DECISION OF THE HISTORIC PRESERVATION OFFICER

CLASS 2 MINOR HISTORIC DESIGN REVIEW CASE NO.: HIS21-16

SUMMARY: A proposal to add a new balcony to the exterior of the Ross House (c.1934).

MAXWELL-ANDERSEN RESIDENCE - BALCONY ADDITION

A104

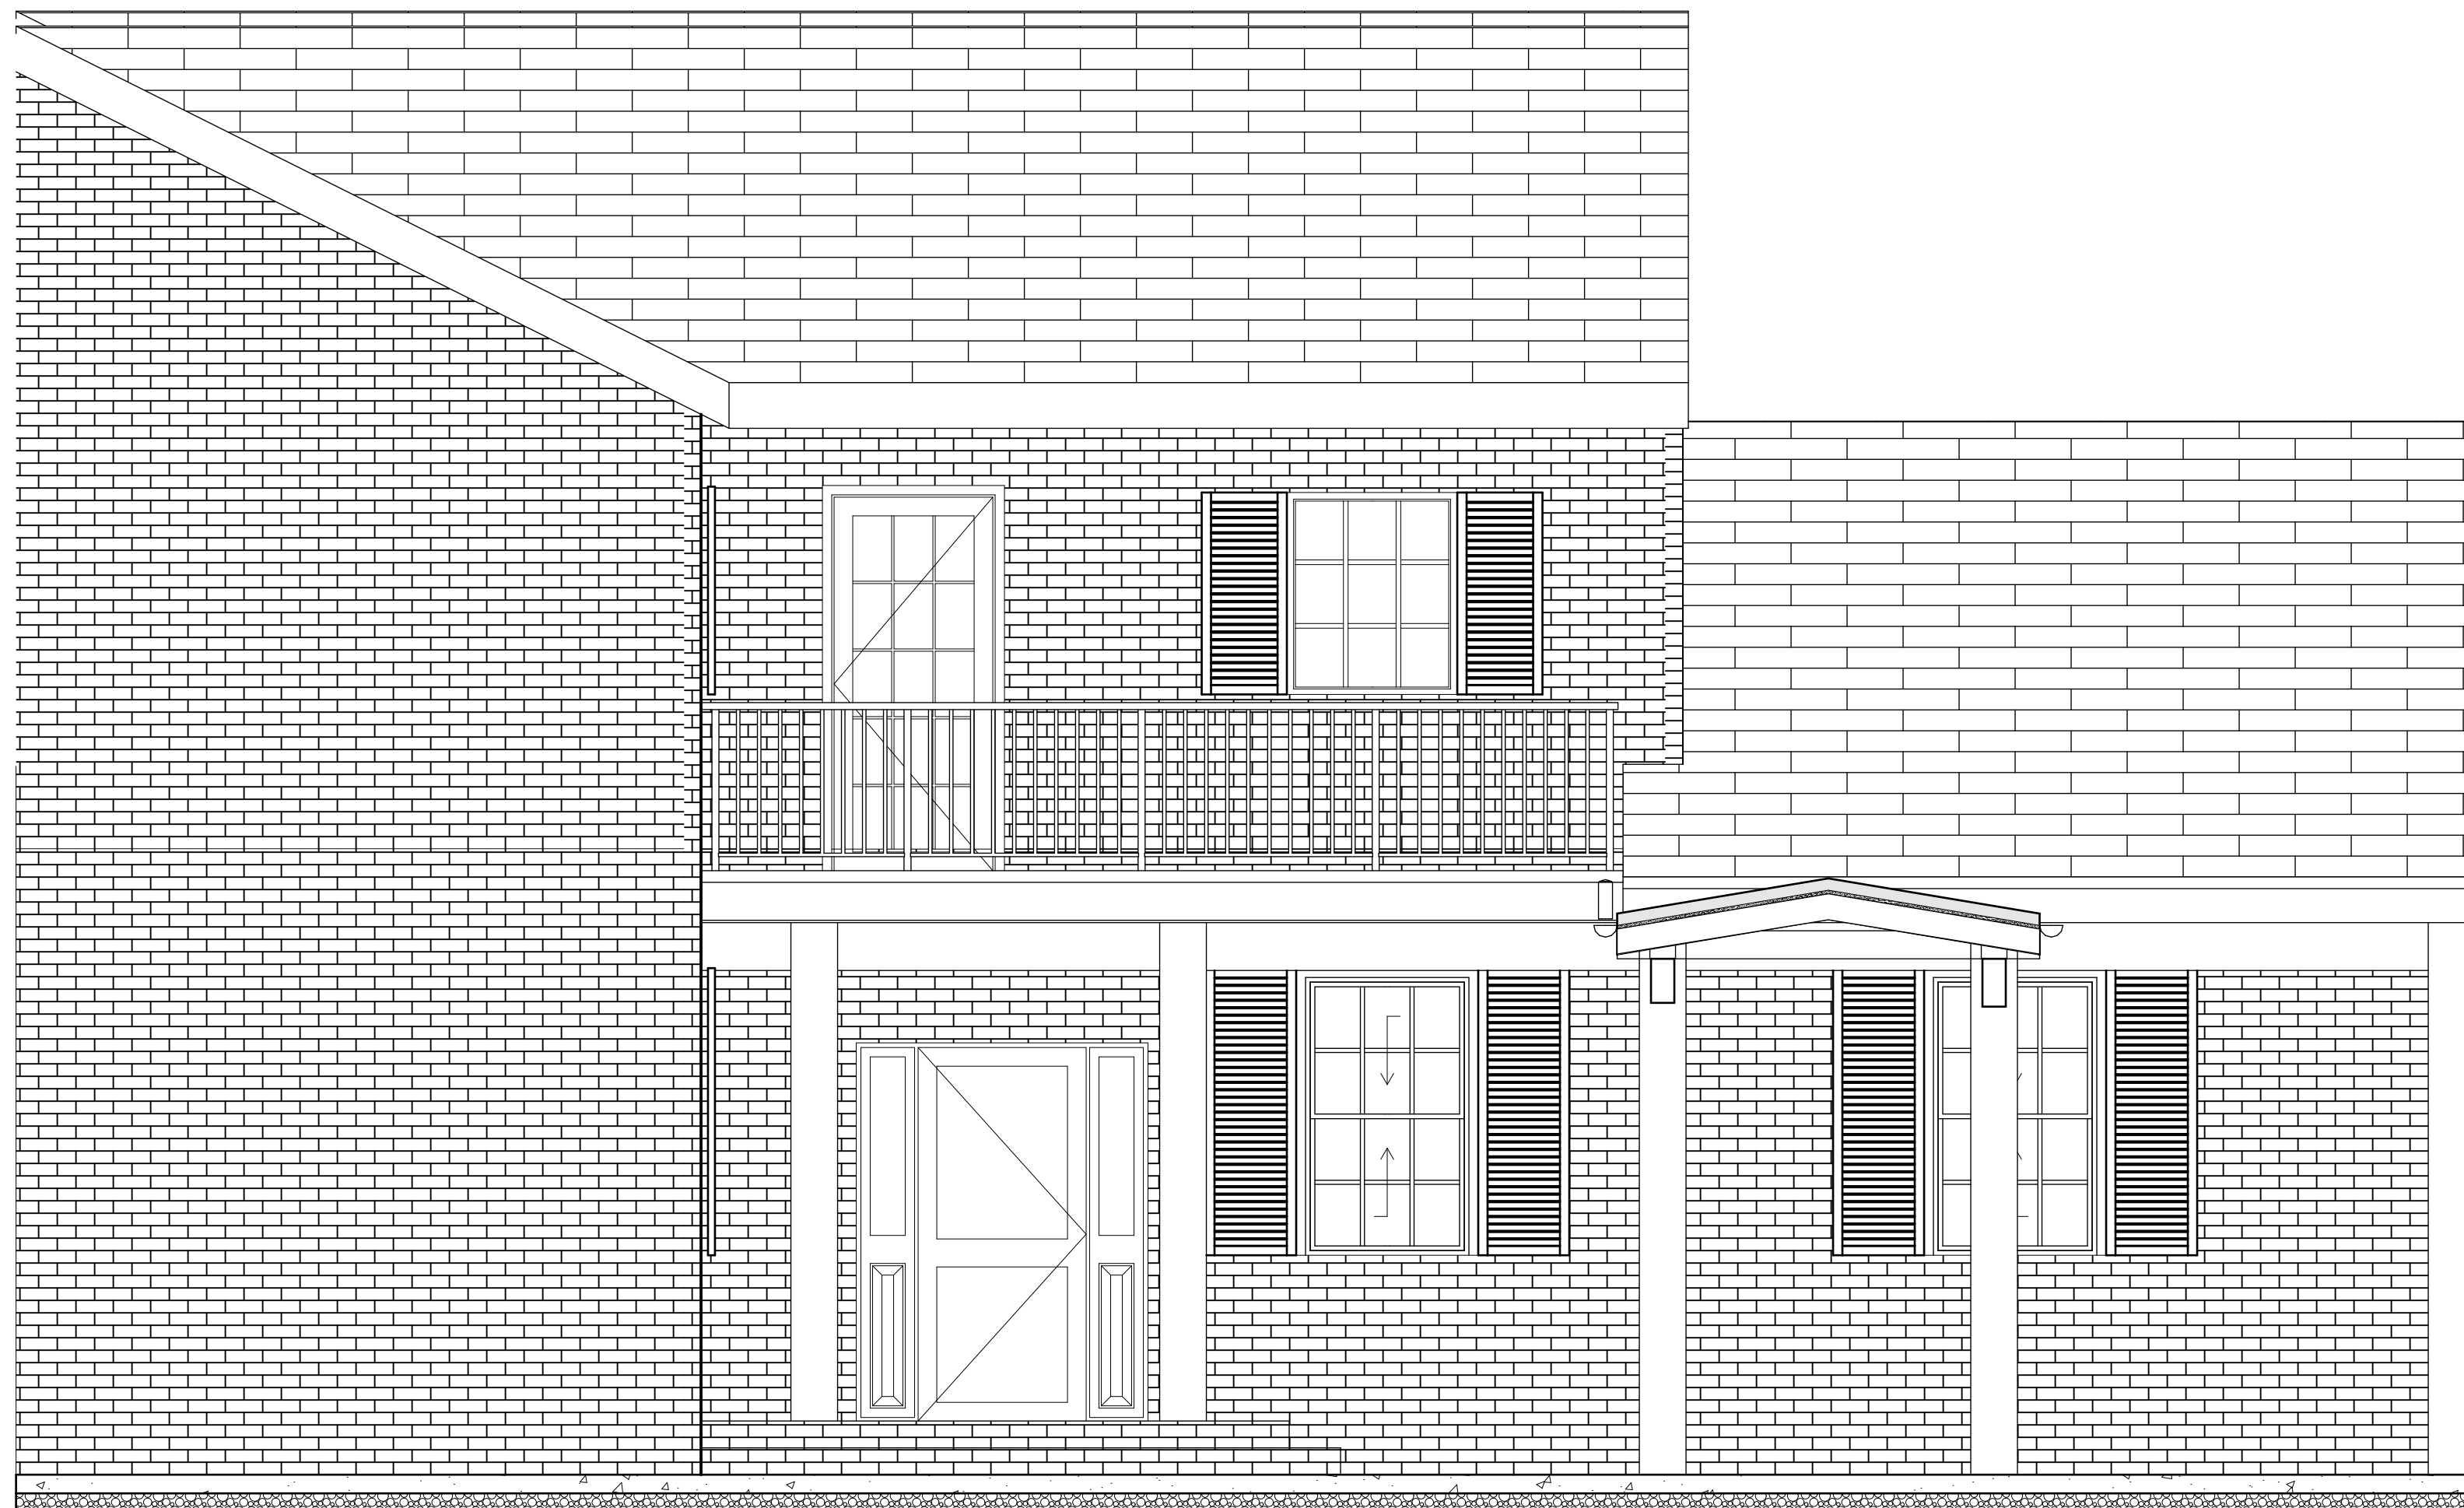
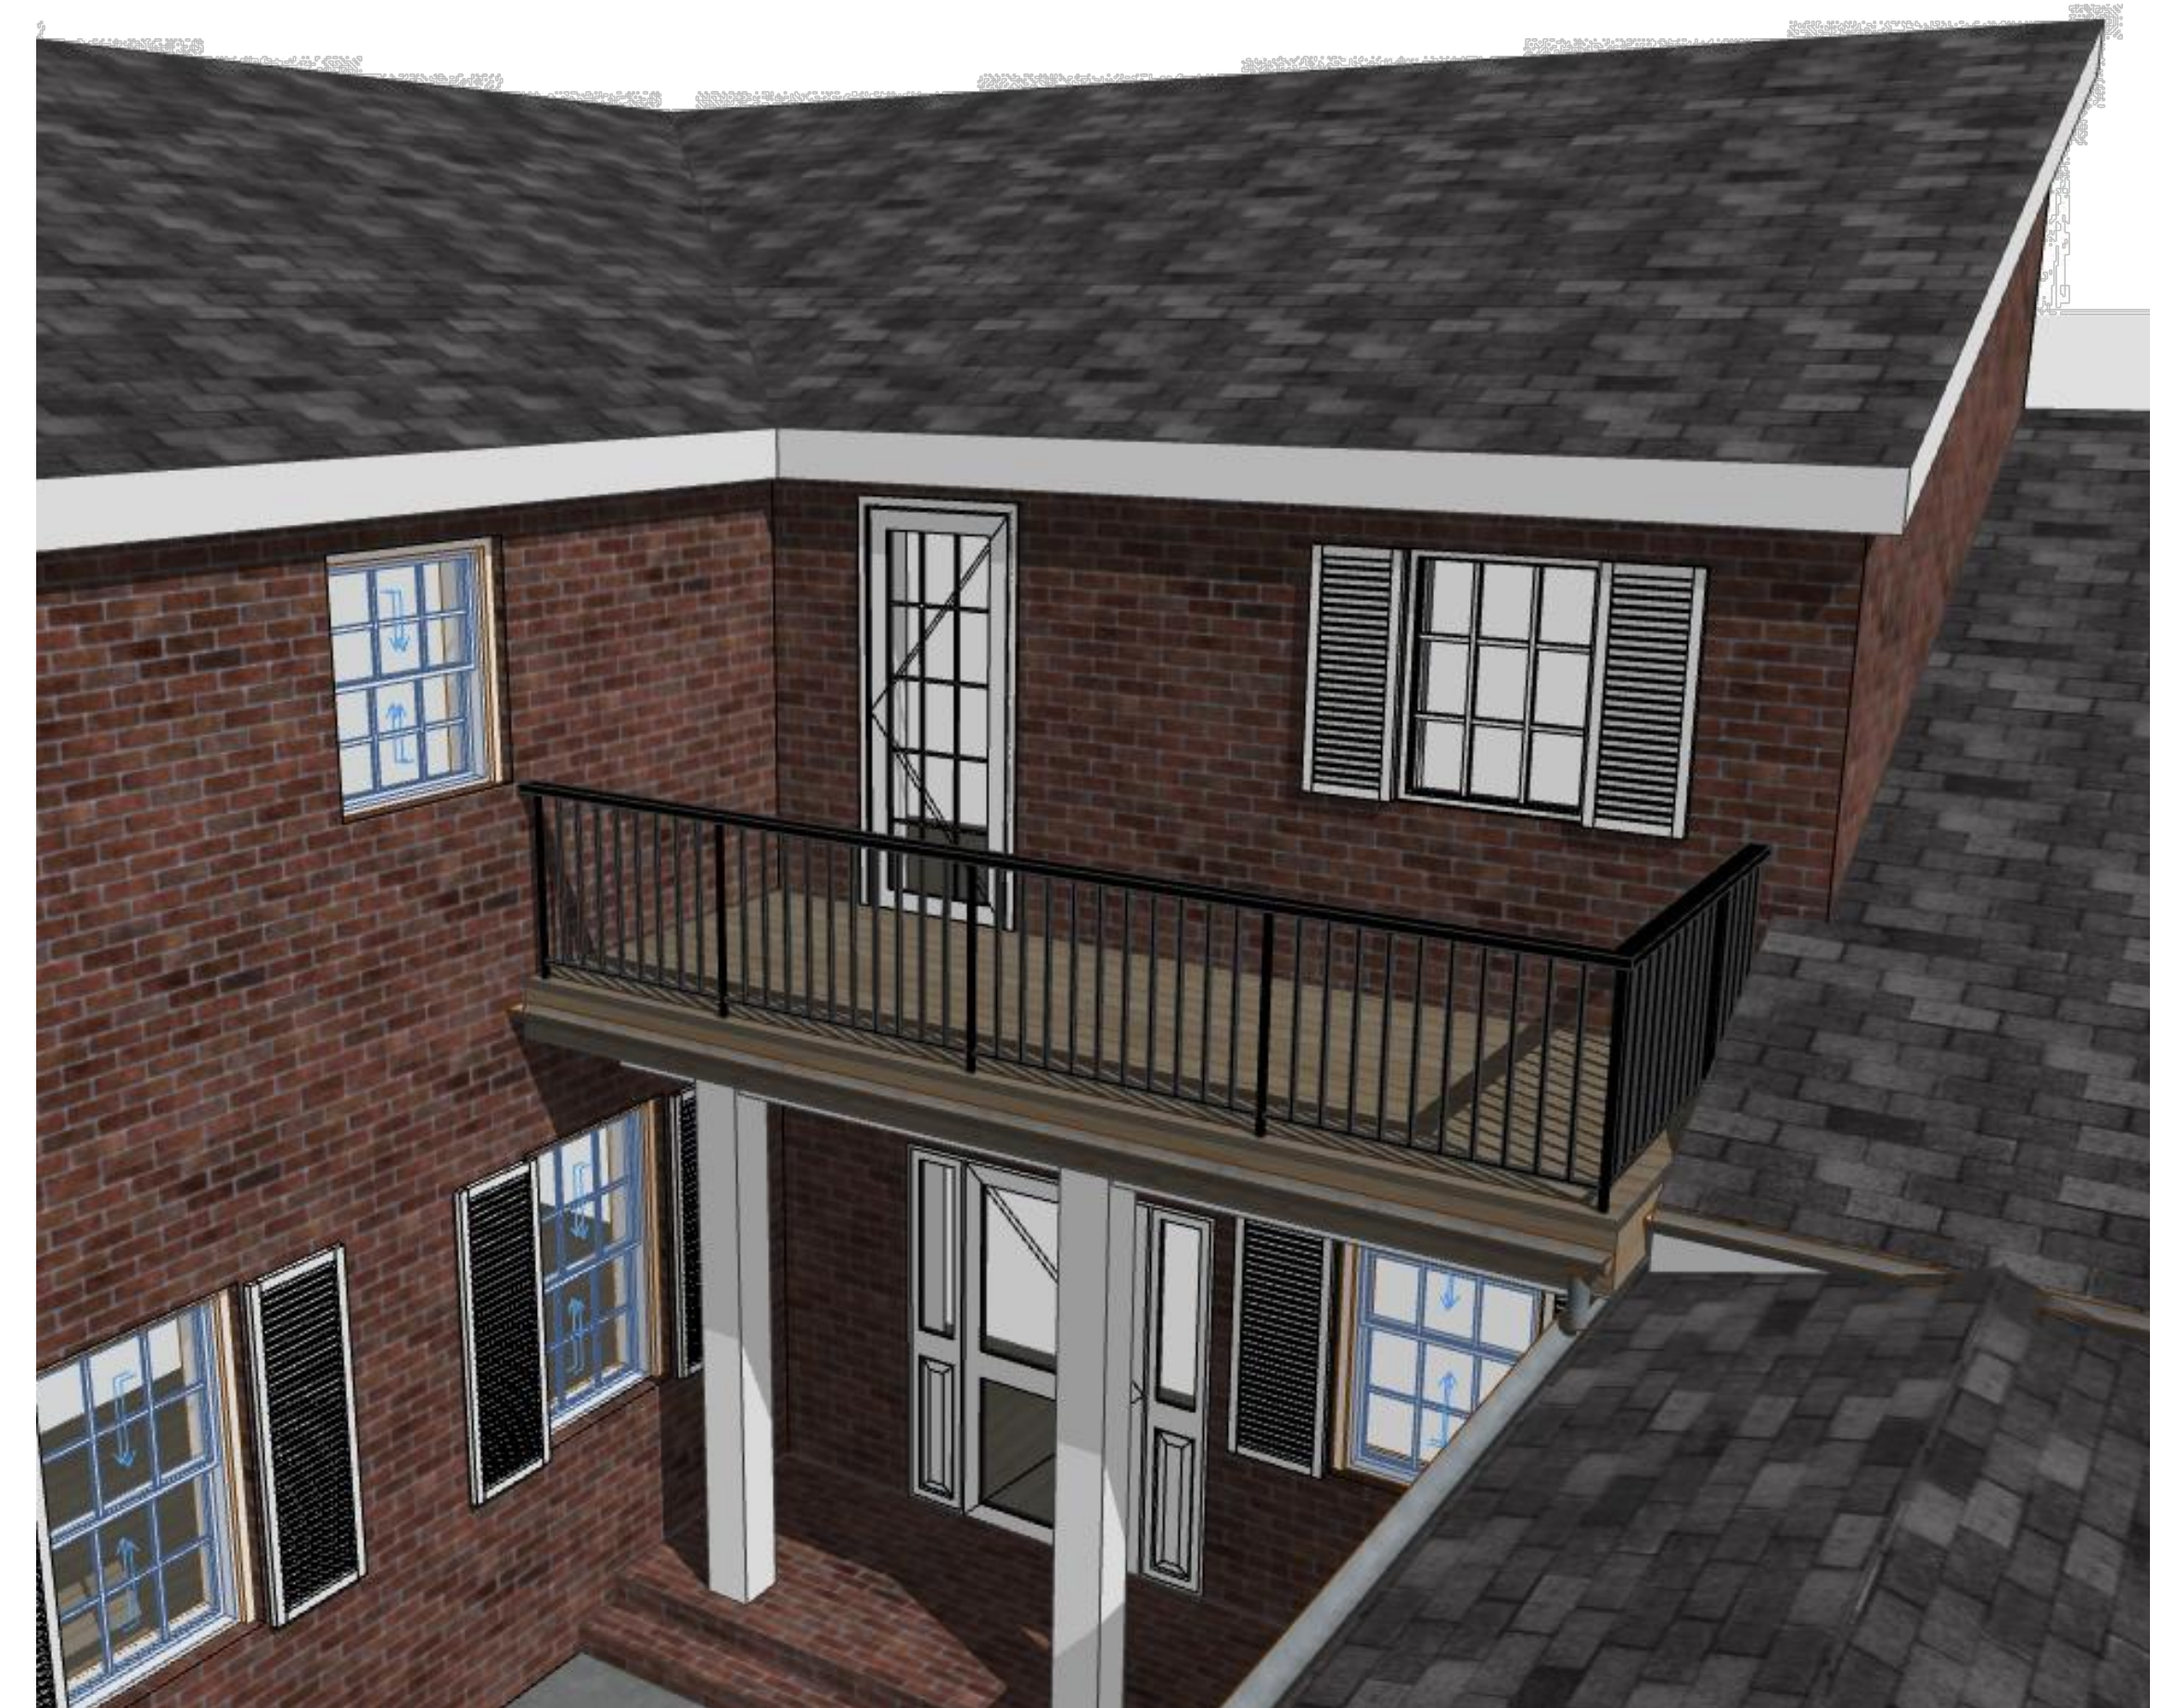
Finding: The proposed balcony and door addition are located within an interior secondary façade at the rear of the Ross House. Staff finds that SRC 230.025(e)(3)(g)(2)(A) has been met.

Finding: The applicant's proposed new exterior balcony will replace an existing shed roof over the first floor patio, and is compatible in material, design and scale with the 1996 non-historic addition as well as the original 1934 portion of the Ross House. Staff finds that SRC 230.025(e)(3)(g)(2)(C) has been met.

Finding: The applicant's proposed new exterior balcony is 111 square feet in size and does not exceed the footprint of the existing 1996 addition. Overall the proposed balcony addition is

A103

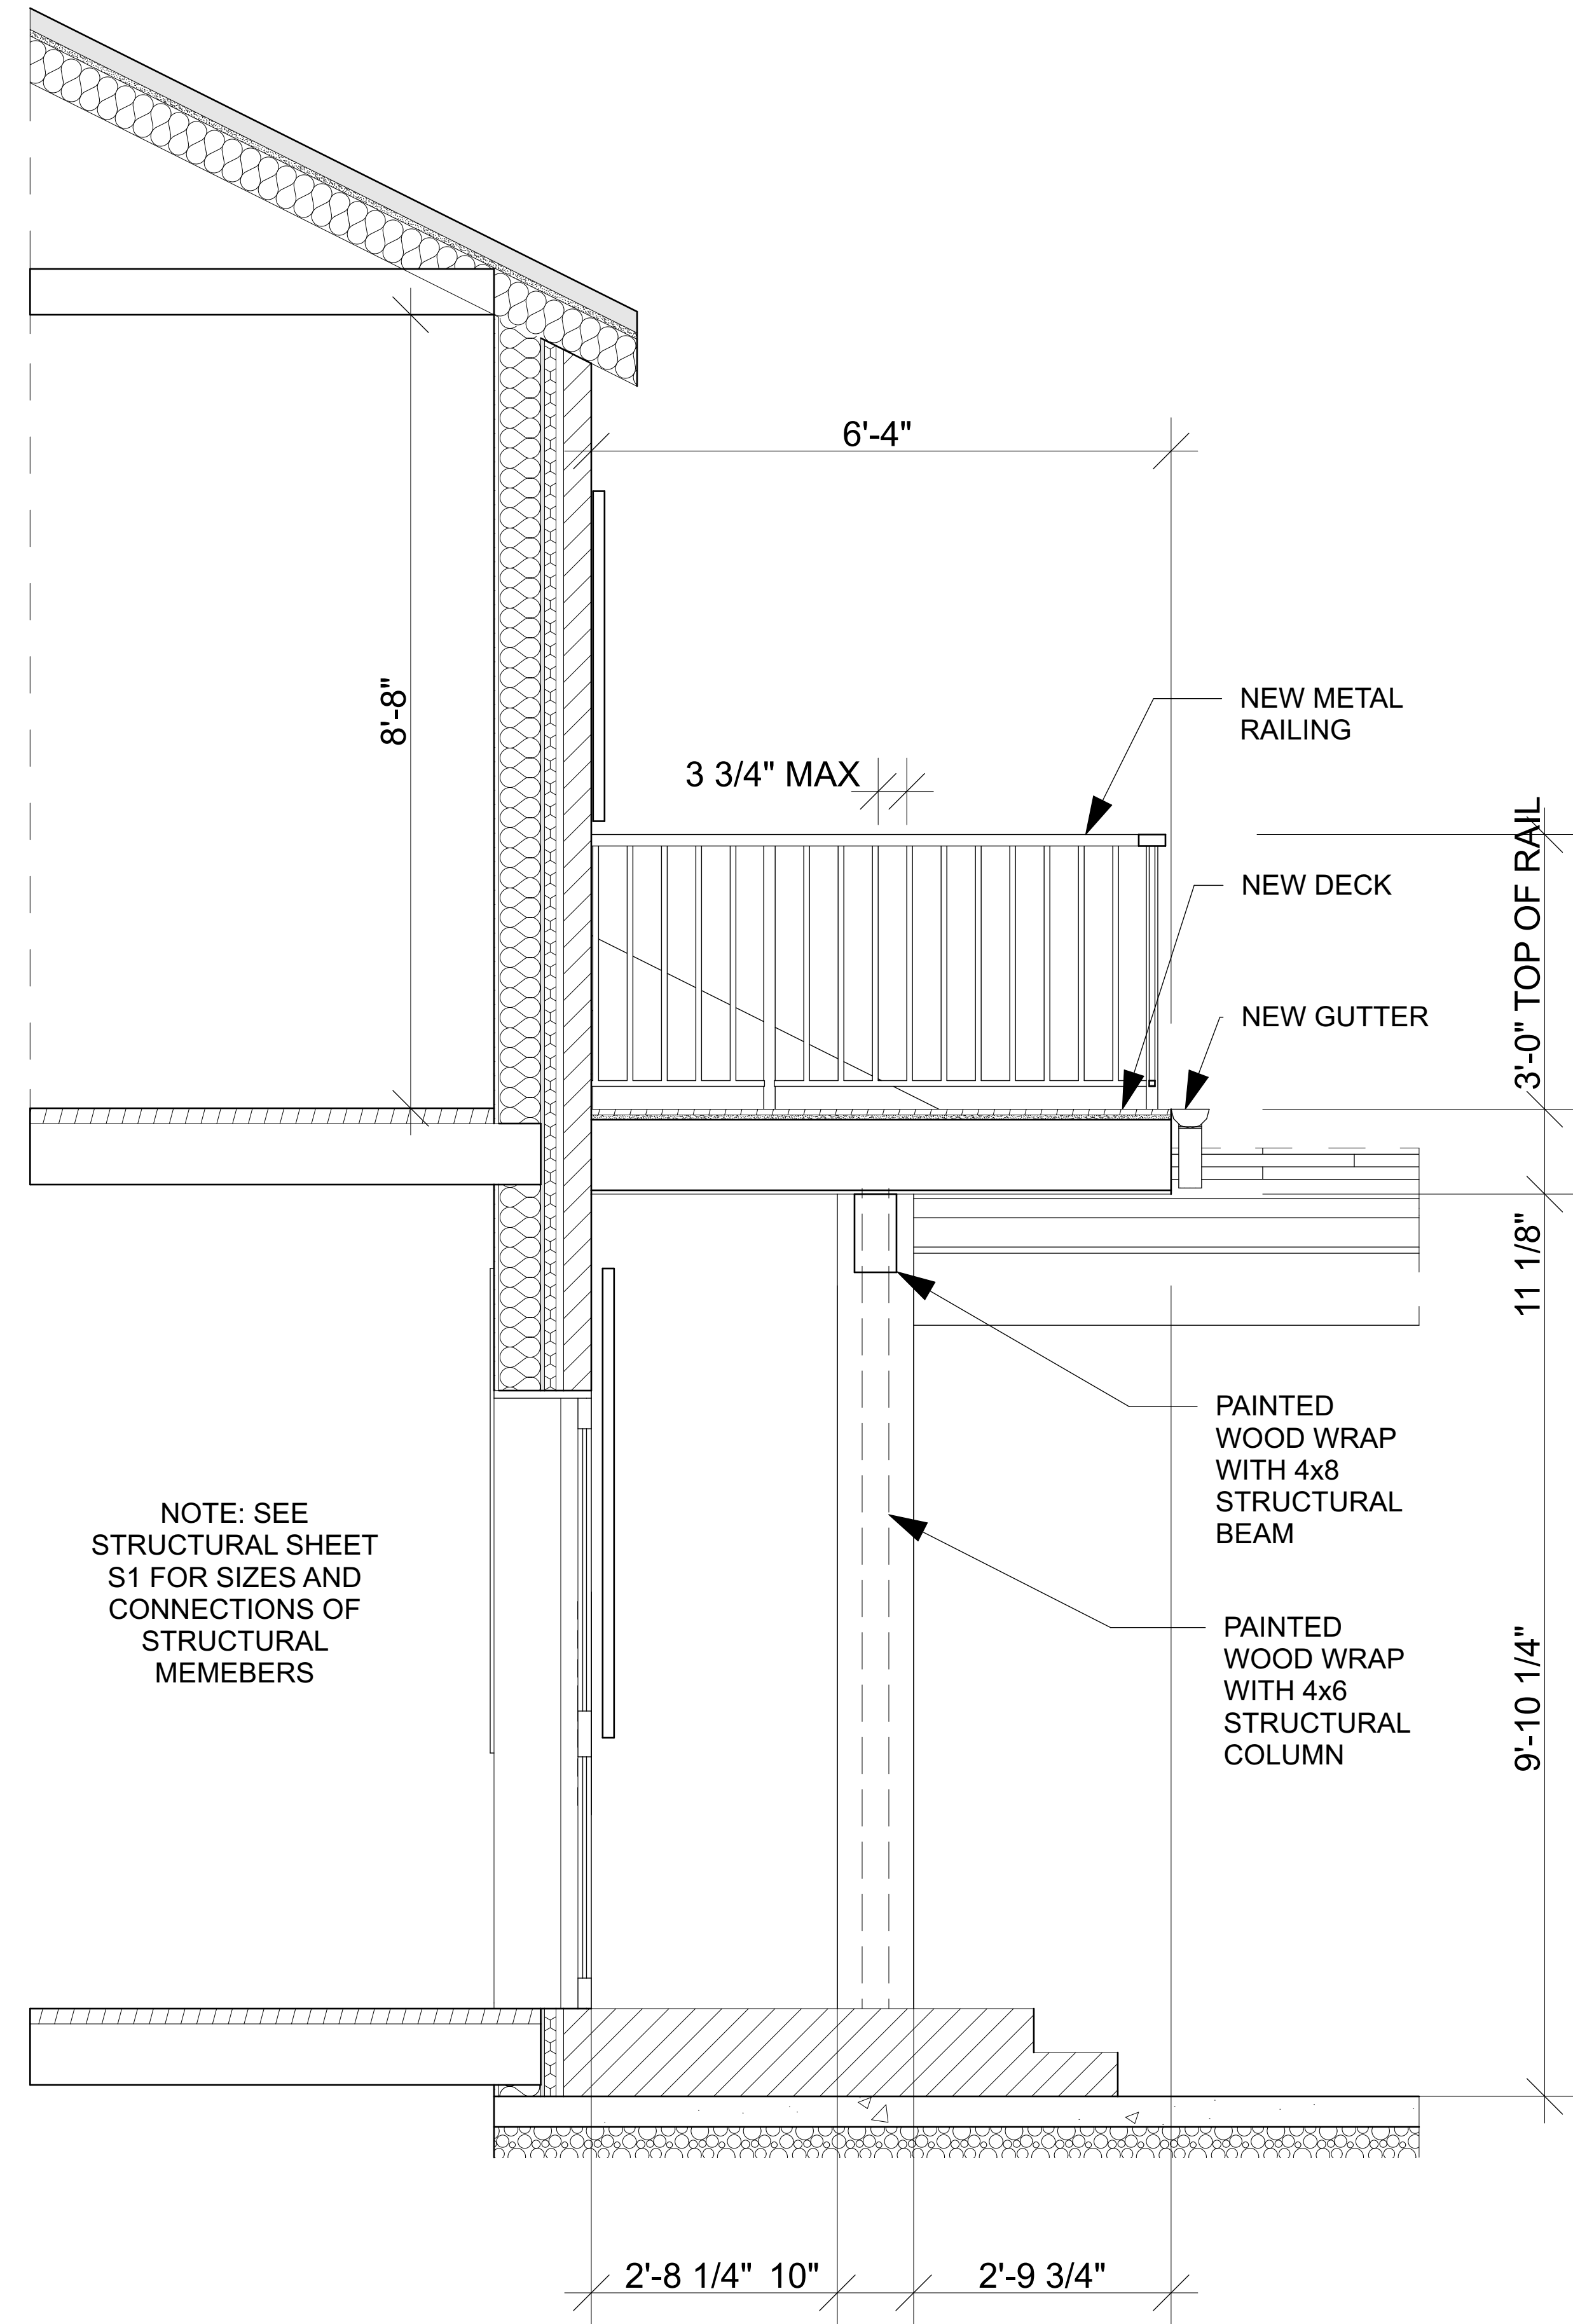
Finding: The applicant's proposed alterations are located within the 1996 non-historic addition at the rear of the Ross House within an interior secondary façade. No alterations to the original 1934 resource are proposed. Staff finds that SRC 230.025(e)(3)(g)(2)(B) has been met.

Finding: The applicant is not proposing to alter or remove any original historic material as part of the proposal to add the new balcony and replace the existing window with a door. No original historic materials will be lost as part of enlarging the window opening to accommodate the door, as this work will be within the 1996 addition. Staff finds that SRC 230.025(e)(3)(g)(2)(G) has been met.
